Changelog

Title: Mini Acrylic Sign Addon

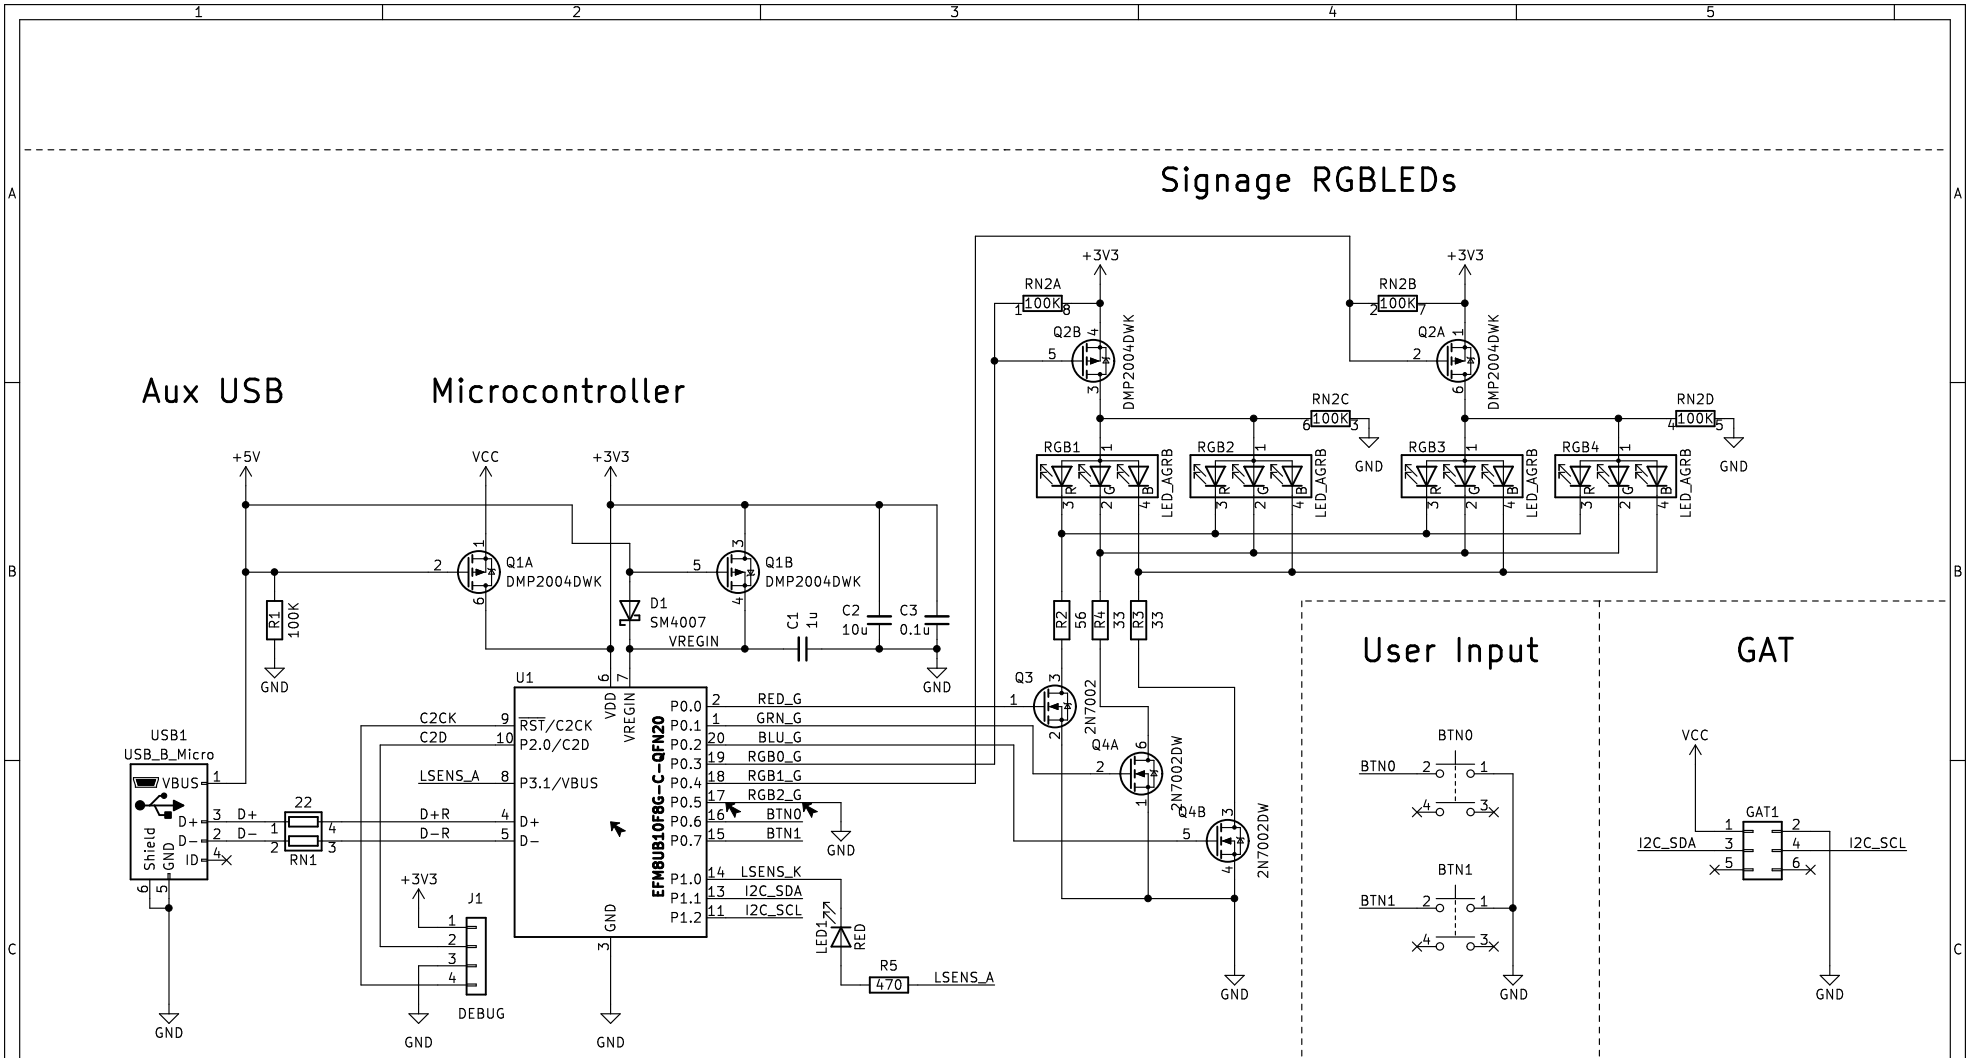
REV3
- fix quadruple checked reversed GAT connector
- cleaned up and labeled schematic

REV4
- fix minor trace fuckup to Q3
- fix missing U1 pin 1 dot
- add via to QFN to gnd plane
  to provide solder flow path
